**AERO ACCESSORIES, LLC
SERVICE BULLETIN**

SERVICE BULLETIN: SB-011

SUBJECT: Possible Damaged O-Ring

APPLICABILITY: Tempest® Electronic Fluid Pump

Figure 1

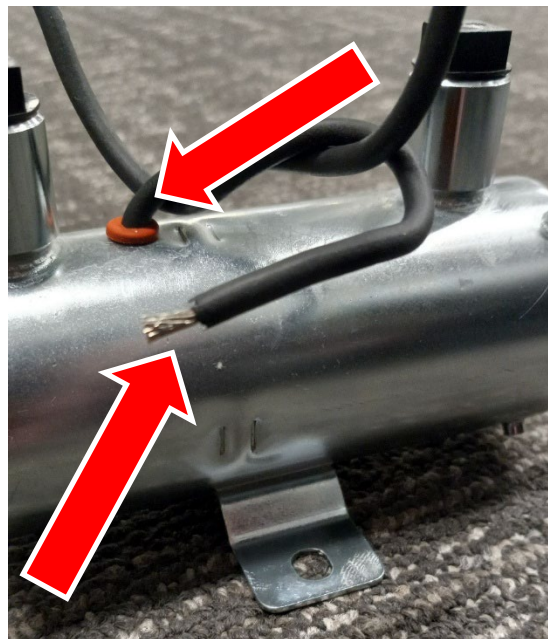
Background: There has been a report from the field of a fluid leak in a Tempest® Electronic Fluid Pump. The area of the leakage was observed at the grommet and, or the end of the lead wire. See Figure 1.

Compliance: When installing a Tempest® Electronic Fluid Pump, operate the pump with fluid. Verify that no fluid is leaking from the fitment points, the end of the lead wire, or around the grommet, See Figure 1. If there is evidence of a leak, do not use the pump, return the pump for an exchange.

Previously Installed Pumps: Tempest® Electronic Pumps that have previously been installed need to be reinspected for leaks within 10 flight hours or 45 days from the effective date of this service bulletin, whichever occurs first. The inspection must be done while the pump is operating and the fluid is present.

If there is evidence of a leak, do not use the pump, return the pump for an exchange.
